Concept Design Report

Bridge 3950A, Cundinup West Rd over
 Padbury Brook, Shire of Nannup

Review Comments

Figure 3-1 Stage discharge curve for Bridge No. 3950.

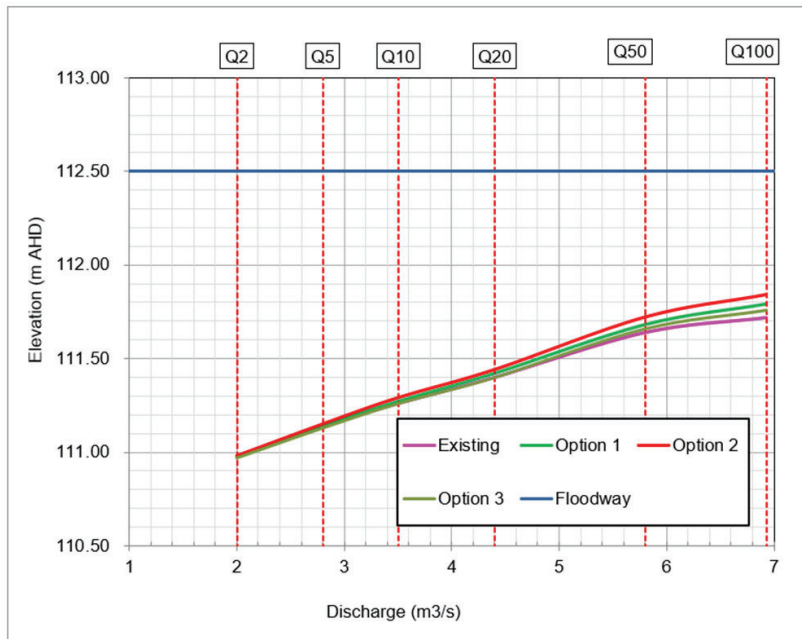
14.	Section 3.8, Page 6, paragraph under Figure 3-1 – clarify why 160mm of backwater is acceptable (e.g. not buildings affected). Also clarify that the box culverts provide better hydraulic performance compared to the pipe culvert in relation to lower backwatering but have higher velocities.	Updated.

3950A-SKT-0001-B

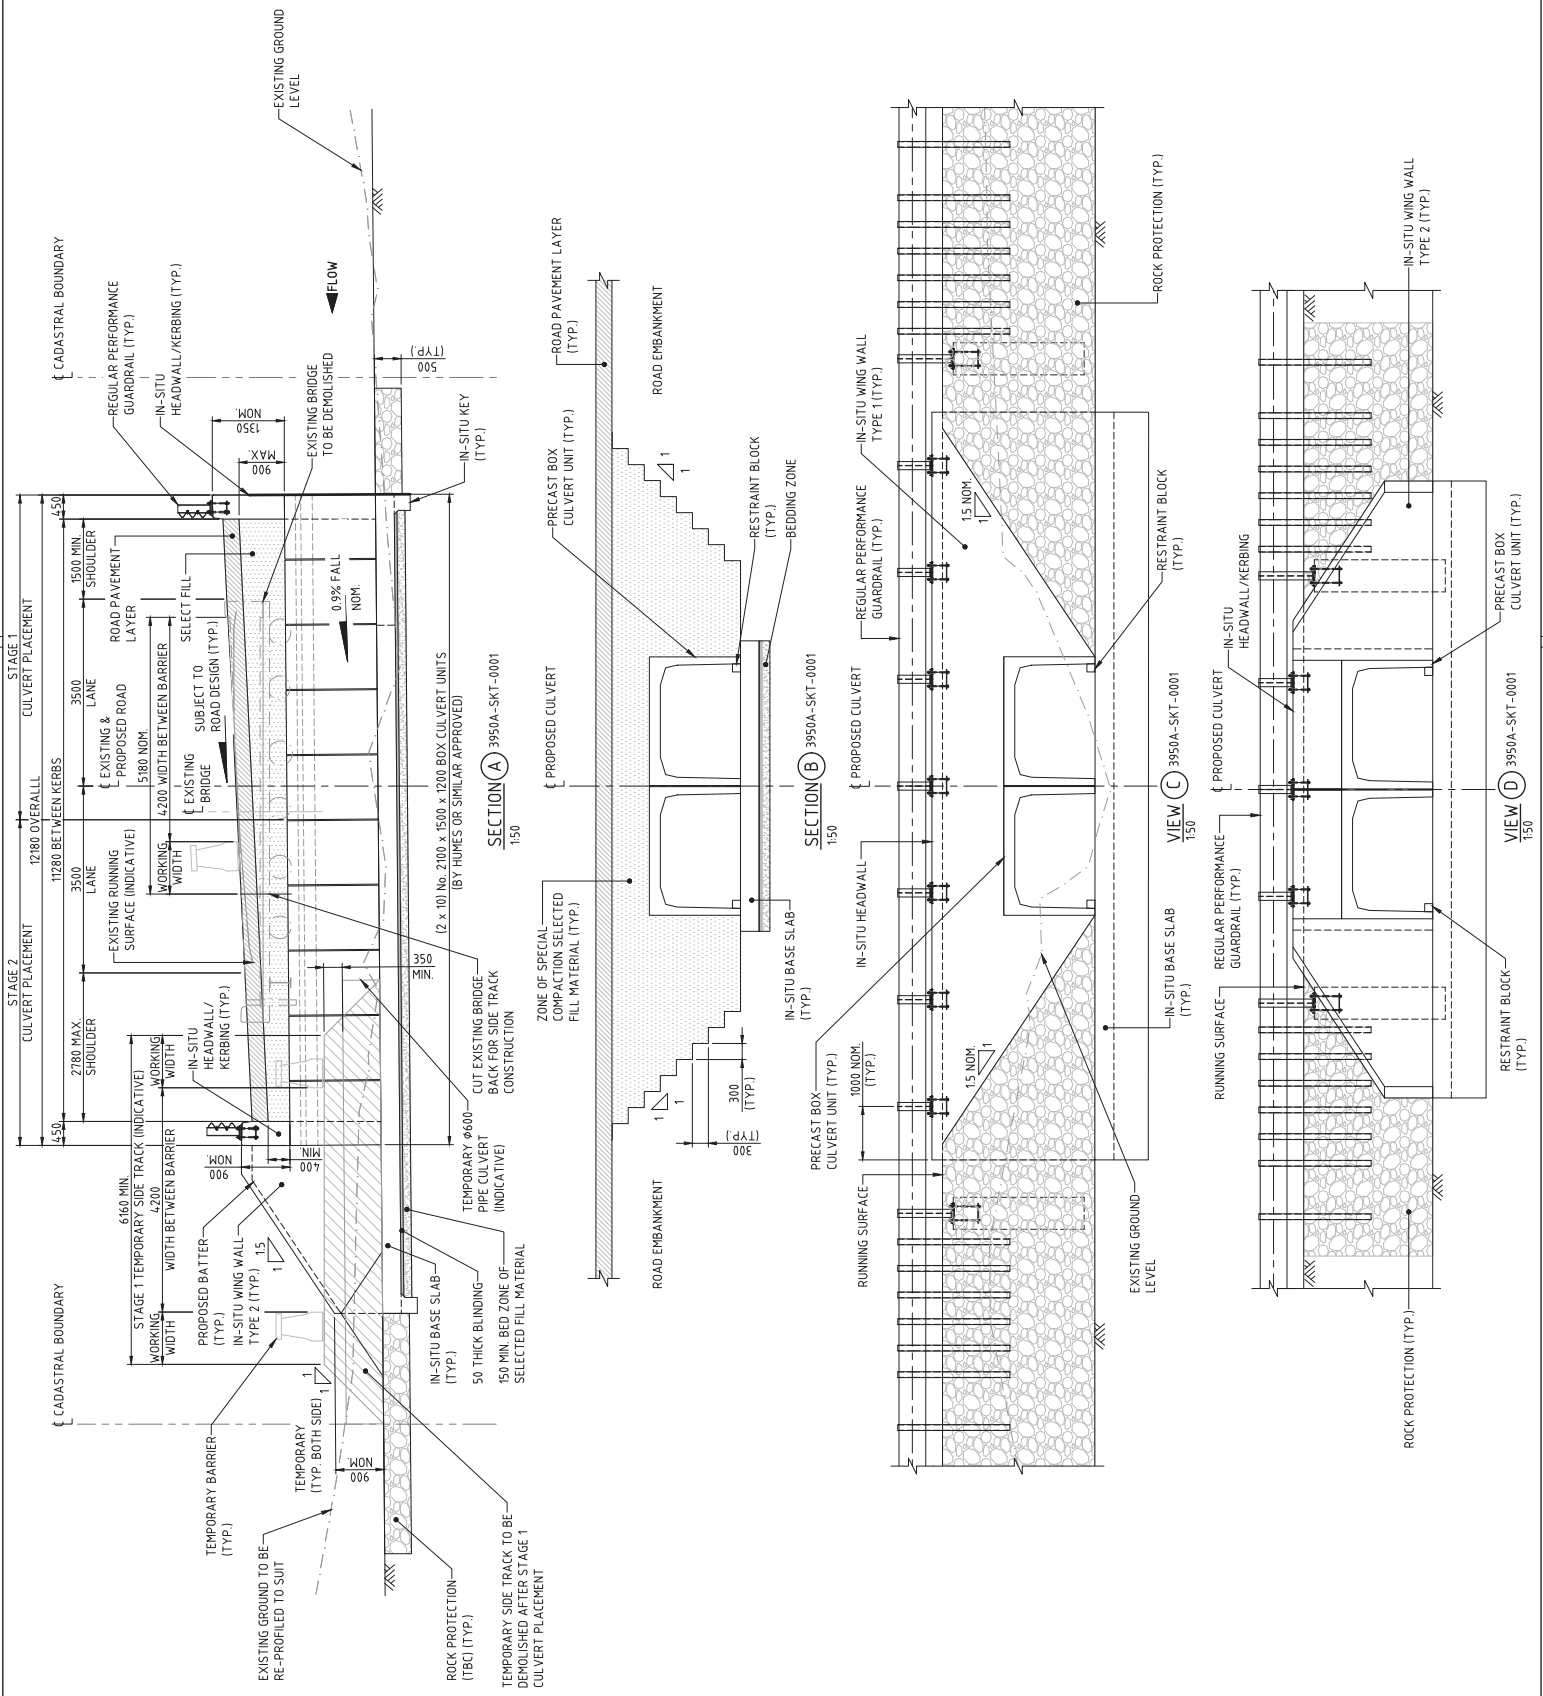
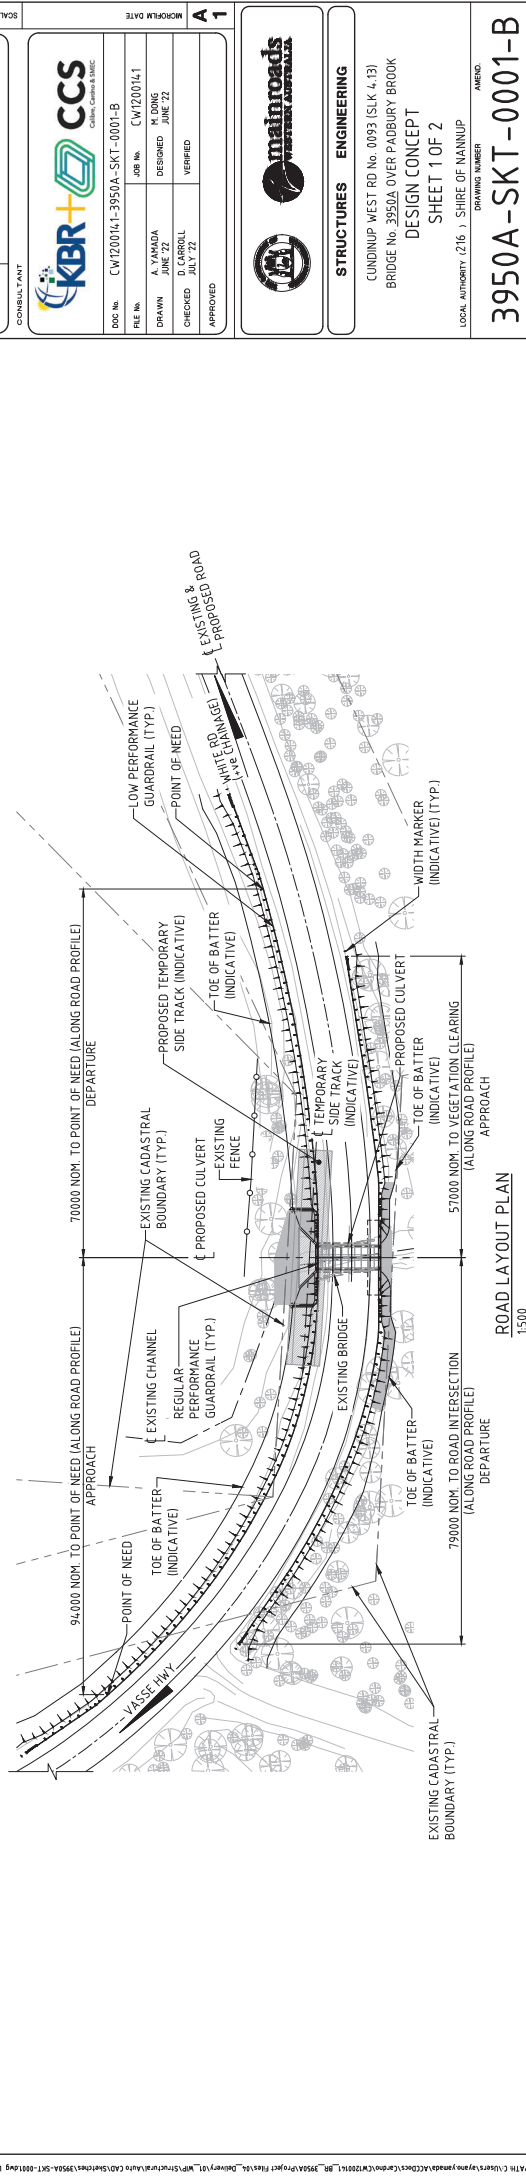
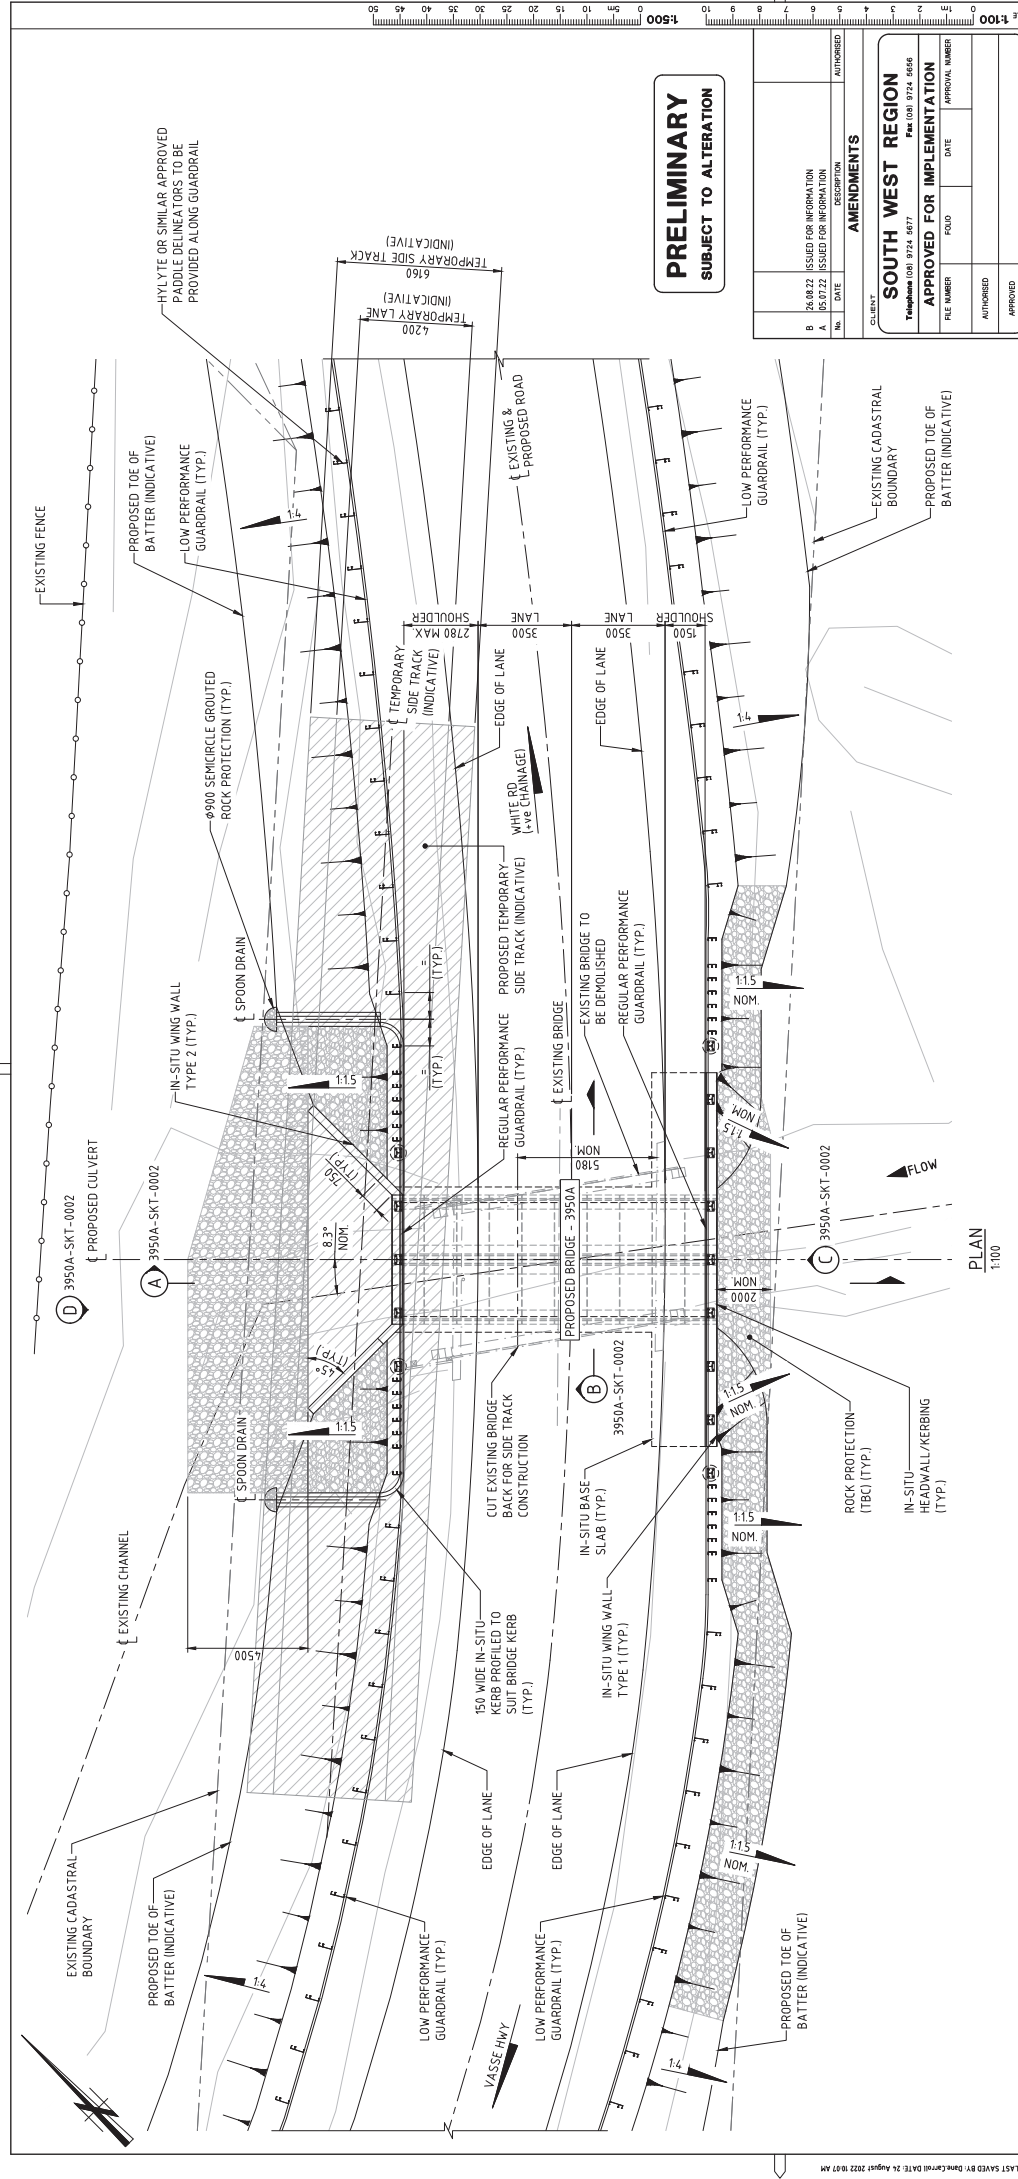
26.	Section 5.1, Page 11- revised based on two stage construction preference.	Updated.
27.	Appendix C, Drawing 3950A-SKT-0001-A, Plan – delete RHS spoon drains. Show skew angle to Brook. Part of the embankment widening at Abut 1 RHS encroaches outside the road reserve, The Shire’s feedback will be sought on this matter – either land take required or retaining wall.	Updated.
